April 12, 2024

Version 5

Warranty Extension: 2017-18 CR-V: DTC P0300, P0301, P0302, P0303, P0304, or P0172; Whirling Noise from Engine

Supersedes 19-037, dated April 29, 2022, to revise the information.

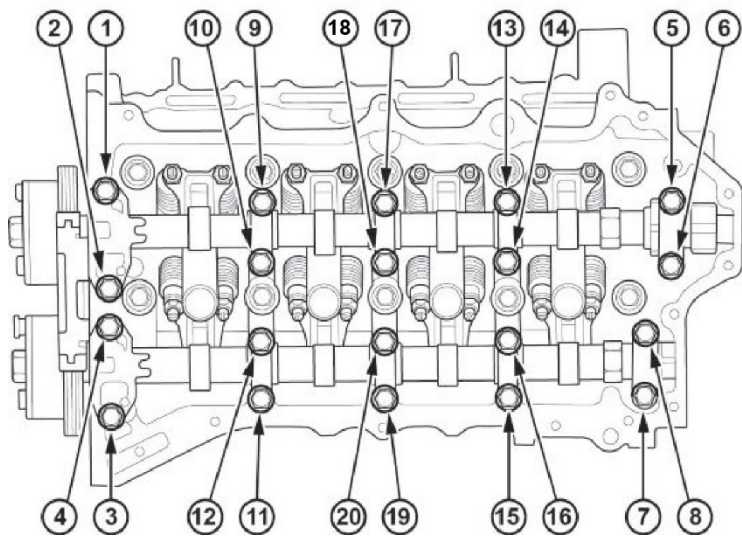
Under CAMSHAFT AND ROCKER ARM ASSEMBLIES REPLACEMENT PROCEDURE, an image in step 13 was revised.

13. Remove the camshaft holder bolts, then remove the camshaft holders. To prevent damaging the camshafts, loosen the bolts as shown, two turns at a time.
